**CABINET MEMBER FOR HIGHWAY MANAGEMENT –
28 APRIL 2022**

**BANBURY: A422 STRATFORD ROAD - PROPOSED 20MPH SPEED
LIMIT**

Report by Corporate Director, Environment and Place

2. This report presents responses received to a statutory consultation on the proposed introduction of a 20mph speed limit on the A422 Stratford Road at Banbury as shown in **Annex 1**.

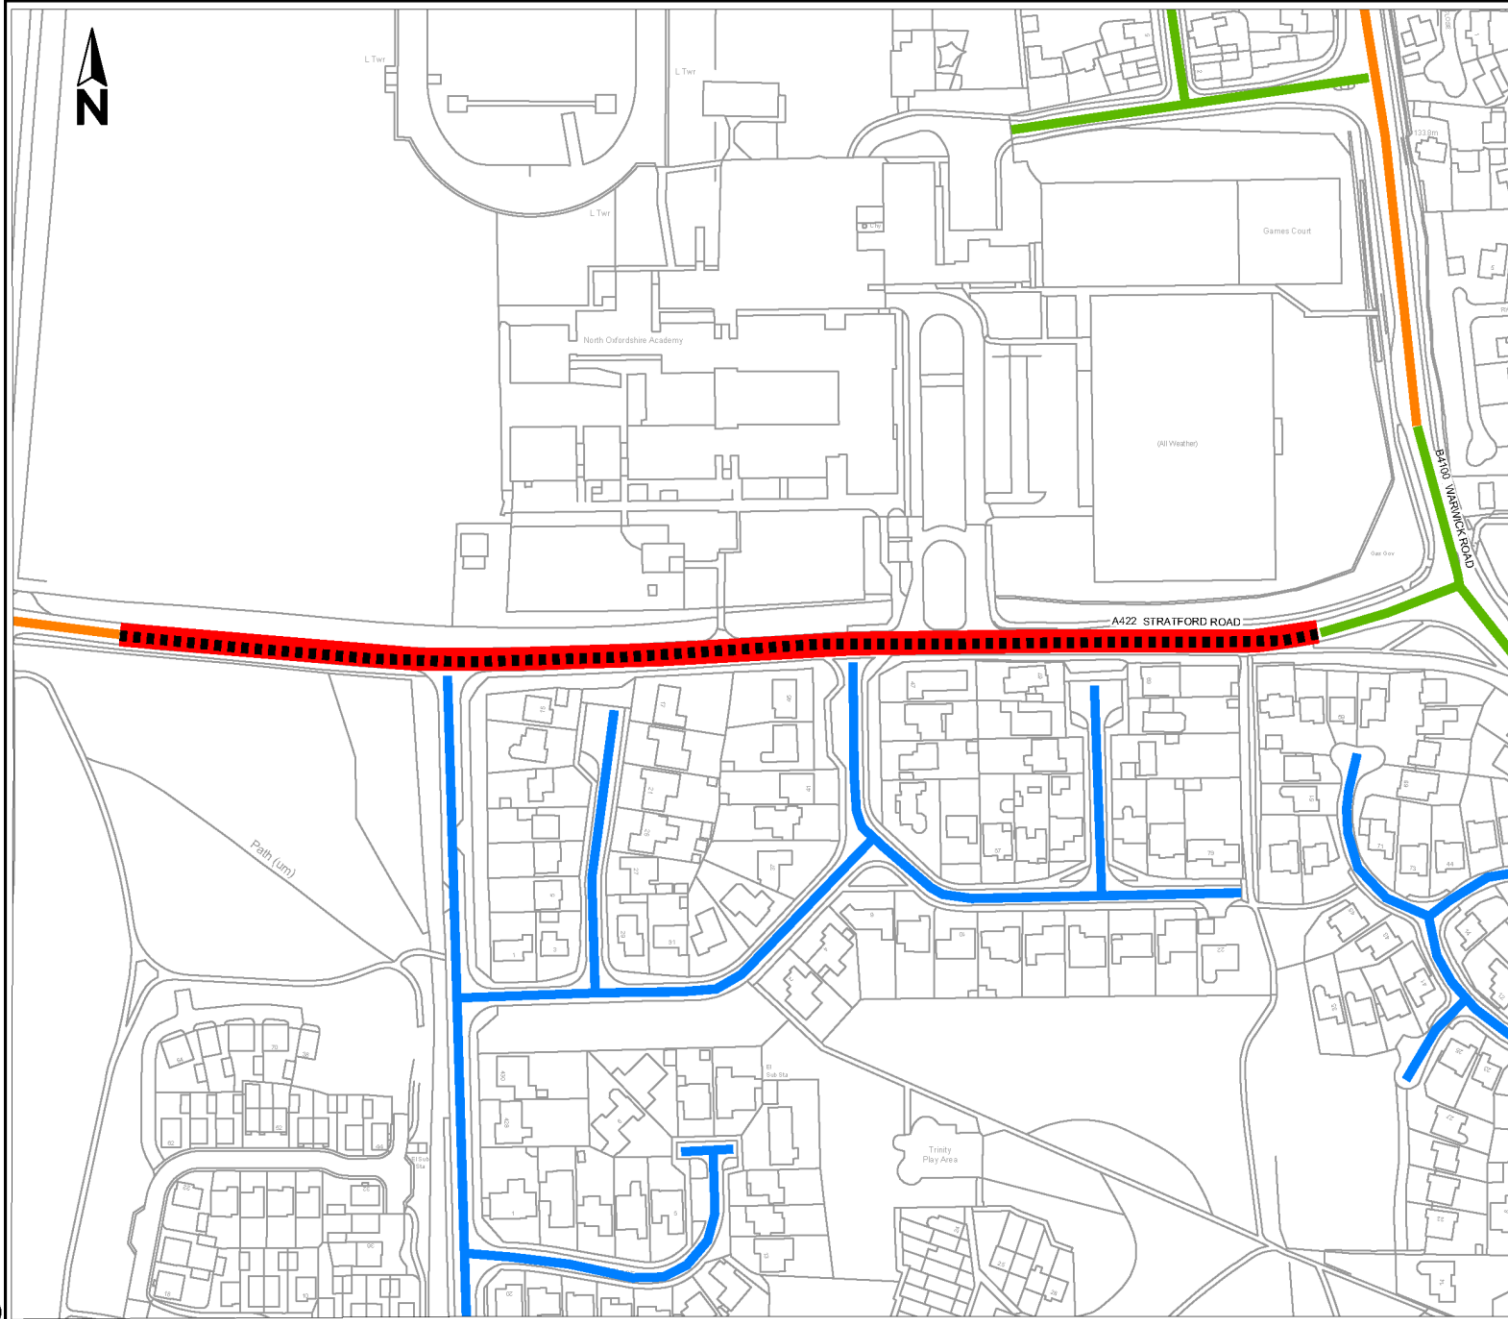
RESPONDENT	COMMENTS
(1) Thames Valley Police, (Traffic Management Officer)	<p>No objection – Thames Valley Police are not opposed to lowering speed limits providing they are appropriate to the road environment and likely to have casualty reduction benefits. All aspects of the proposed speed limit are taken into account i.e. collision history, speed of existing traffic, road environment, enforcement, road character and driver perception etc.</p> <p>The current speed of traffic is a reliable indicator of how acceptable a new speed limit would be. The recognised way of ascertaining this level of self-compliance is the mean speed. If the mean speed is 4 mph or more over the proposed limit it is unlikely to be effective without other measures such as engineering or continual enforcement.</p> <p>There is a proven link between road environment/character and driver's speed. Drivers must respect the need for a speed limit. If it is not accepted as realistic it will quickly be abused and be the source of constant demands for police action. The police stance still reflects that 20 mph limits and zones should still be self-enforcing.</p> <p>The policy of Thames Valley Police is to use sound practical and realistic criteria (Circular Roads 1/2013) when responding to Highway Authorities in an effort to promote consistency and to reduce the burden of constant and unnecessary enforcement. The advice shown in Circular Roads 1/2013 states Speed Limit should not be used to attempt to solve the problem of isolated hazards, for example a single junction or reduced forward visibility. No speed data has been received in support of these proposals.</p> <p>I acknowledge the presence of a large School within this proposed limit but raise concern at the level of compliance that a signed only limit is likely to achieve. I strongly urge should this proposal go ahead it is monitored with a view to additional engineering measures going forward.</p> <p>Future complaints of poor compliance must be directed in the first instance to the Highway Authority. Having visited the location this week can I make you aware there are 30 repeater speed limit signs within a street lit area which is not permitted.</p>

<p>(3) Local County Cllr, (Banbury Ruscote division)</p>	<p>Support – Can you note that I as local member for Banbury Ruscote fully endorse a 20MPH implementation after due process of consultation from Banbury rise junction to the traffic lights at Warwick road on the A422 Stratford road in the proximity of North Oxfordshire Academy School.</p>
<p>(4) As an individual, (Banbury, Bailey Road)</p>	<p>Object - In practice 30mph is ok on this stretch - queues and pedestrians using the zebra naturally slow the traffic anyway at busy times. The real problem is the 40mph zone between Bretch Hill and Drayton which should be reduced to 30mph. It briefly encourages traffic to accelerate and then drivers are reluctant to slow down - that's the real danger.</p>
<p>(5) As an individual, (Banbury, George Parish Road)</p>	<p>Object - This road is generally not that busy outside school drop off and pickup times when traffic is at stand still either because of the two crossing on this road or buses or cars trying to turn in to the school so speed reduction with the school in mind is pointless.</p> <p>The only issue with speed on this road is the vehicles who are exceeding the current speed limit of 30mph which is an issue on many others reducing the speed limit to 20mph will not stop those who are happy to exceed the current limit as proved on other 20mph road i.e Bretch hill road from the Stratford Road turning until the second chicane where some car accelerate to high speed some of the worst offenders must be doing 60mph by the time they have to brake. This road is a straight road with plenty of safe crossings on it so in my mind this idea make no logical sense.</p>

<p>(6) As an individual, (Banbury, Ironstones)</p>	<p>Object - I object. There is only one turning onto the Bretch Hill estate on this road. Nothing has changed. This is unnecessarily complex Schoolchildren cross this road twice a day. Other schoolchildren get deposited and picked up by car twice a day. Traffic is very slow at these times. Otherwise, this is the main route to Stratford.</p>
<p>(7) Online response, (Banbury, Warwick Road)</p>	<p>Object - Said road has already been changed several times. Makes no sense to go from 40mph to 20mph. Better to rezone as 30mph all way from Drayton village to junction of Warwick Road.</p>
<p>(8) As an individual, (Banbury, Warwick Road)</p>	<p>Object - There is no need, there are no accidents, more often than not the traffic is too heavy to allow for fast speeds put your efforts into areas that need it</p>

<p>(9) As an individual, (Oxford, Rymers Lane)</p>	<p>Object - This is a major 'A' road into Banbury from the West and such a low-speed limit is completely unreasonable.</p>
<p>(10) As an individual, (Banbury, Bath Road)</p>	<p>Support - More people are living, working and walking (and cycling) in this area, which also passes the front of a large secondary school (NOA). Many students cross the road here and many cars turn in and out. Slower speeds here are a very sensible measure to improve safety and also help to encourage more people to walk and cycle. I hope that signage will clearly show the new limit.</p> <p>I would also strongly support the extension of 20mph limits to all residential areas of Banbury for similar reasons to those stated above. Encouraging more active travel will also help to reduce pollution and otherwise improve peoples' health and fitness. Feeling safer on the road as a result of motor vehicles moving more slowly is an important intervention to encourage this.</p>

<p>(11) As an individual, (Banbury, Bretch hill)</p>	<p>Support - It should calm traffic and make the area safer for surrounding schools and residents. However, consideration needs to be given to enforcement of the new speed limit.</p>
<p>(12) As an individual, (Banbury, Broughton Road)</p>	<p>Support - I believe that a reduced speed limit will help to reduce accidents involving vehicles, pedestrians & animals along this road although I have lived in Banbury for 10 years I regularly visit Coventry where numerous traffic calming methods have been introduced & these seem to be working well.</p>
<p>(13) As part of a group/organisation, (Banbury, Hillside Close)</p>	<p>Support - This road passes the North Oxfordshire Academy (NOA), and therefore there are many pedestrians and cyclists - including children -use that road on a daily basis. It would be much safer for them as well as for the people who live around that area if the speed limit was 20mph. It will also help build a safer and greener town in general, where people are prioritised over motor vehicles.</p>

<p>(14) As an individual, (Banbury, Longfellow Road)</p>	<p>Support - This junction is already busy and with the increased traffic from the Bloor homes Banbury Rise estate there is increased chance of a collision, so keeping it at 20 is good. Also, the Banbury Fringe Walk from the south exits onto the A422 at this point, so slower traffic will make it easier to cross the road on foot to continue the walk. However, the A422 will end up with a short stretch of 40mph between a 20mph section (Banbury Rise) and 30mph (Drayton</p>

village) which seems nonsensical. Why not make that section 30mph as well, to make it contiguous with the Drayton limit? As a driver I never accelerate into the 40 section because it is so short!

(15) As an individual, (Banbury, Nursery Drive)	Support - To make the space safer for pedestrians and cyclists
(16) As an individual, (Banbury, Osterley Grove)	Support - I'm a local delivery driver, and at busy times when the schoolchildren are using the paths and crossings, people need to slow down. This will hopefully avoid accidents. The current 30-40-30 into Drayton is pointless as it stands, as once you get to 40 you immediately have to slow down to 30 again. It should be 20 by the school and 30 through Drayton.

(17) As an individual, (Banbury, Townsend)	Support - This is a narrow road which I frequently cycle along. Cars and lorries often come up at speed behind me and are then forced to brake because it's not possible to pass, either because of oncoming traffic or because of poor visibility. A 20mph limit would make this road much safer for cyclists and pedestrians.
